Access Compliance Report Public Rights-of-Way (Curb Ramps)

Main Street: VISTA_LOMA Cross Street: ESPERANZA_RD Location: NW

ADA ID: RPAT210923133409 Ramp Type: Type 1 - Perpendicular Initial Pass/Fail: Fail Overall Compliance: No Severity Score: 15

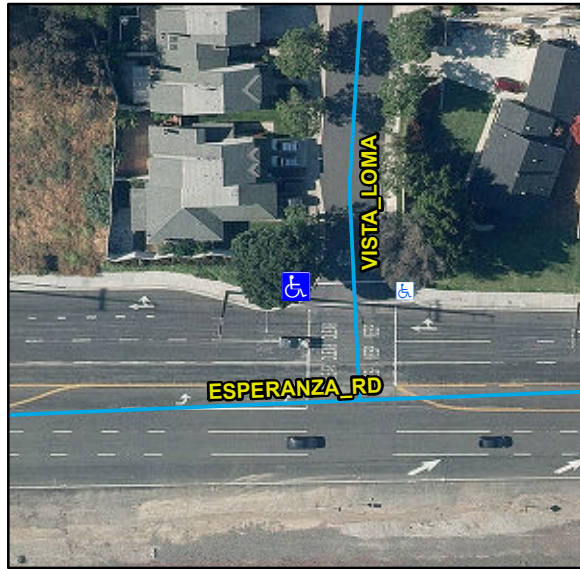
Compliance	Description	Data	Compliance	Description	Data
N/A	Ramp Length (in)	63	N/A	Flare Type LT	
Yes	Ramp Width (in)	89			N/A
No	Ramp Run Slope (%)	8.4	N/A	Flare Slope LT (%)	N/A
Yes	Ramp Cross Slope (%)	0.9	N/A	Flare Traversable LT	N/A
N/A	Landing Present	N/A	N/A	Flare Type RT	
N/A	Landing Length (in)	N/A			N/A
N/A	Landing Width (in)	N/A	N/A	Flare Slope RT (%)	N/A
N/A	Landing Run Slope (%)	N/A	N/A	Flare Traversable RT	N/A
N/A	Landing Cross Slope (%)	N/A	N/A	DWS Provided	N/A
N/A	Landing Movement Obstructed?	N/A	N/A	DWS Contrast	N/A
	Landing Movement Type	N/A	N/A	DWS Length (in)	N/A
N/A	Landing Shared	N/A	N/A	DWS Full Width	N/A
N/A	Clear Space	N/A	N/A	DWS Offset Left (in)	N/A
N/A	Clear Space To Crosswalk (in)	N/A	N/A	DWS Offset Right (in)	N/A
N/A	Marked Crosswalk 1	Yes	N/A	Marked Crosswalk 2	N/A
	Crossing 1 Direction	E		Crossing 2 Direction	N/A
	Marked Crosswalk 1 Width (in)	130		Marked Crosswalk 2 Width (in)	N/A

N/A	Ramp Inside Crosswalk 1	Yes	Yes	Ramp Inside Crosswalk 2	N/A
	Crossing 1 Slope (%)	0.3		Crossing 2 Slope (%)	N/A
	Crossing 1 Cross Slope (%)	2.5		Crossing 2 Cross Slope (%)	N/A
N/A	Gutter Ponding	N/A	No	Curb Slope	22.4
Yes	Gutter Lip Height (in)	0		Road Run Slope (%)	N/A
N/A	Gutter Run Slope (%)	N/A		Road Cross Slope (%)	N/A
N/A	Gutter Cross Slope (%)	N/A			
Yes	Overall Surface Condition: Acceptable		Yes	Perp Joint Present	Yes
	Cross Gutter Present?	No		Spandrel Present?	No
	Replace Cross Gutter?	N/A		Replace Spandrel?	N/A

Remove & Replace Entire Ramp.

R304.2.2, STD 1115
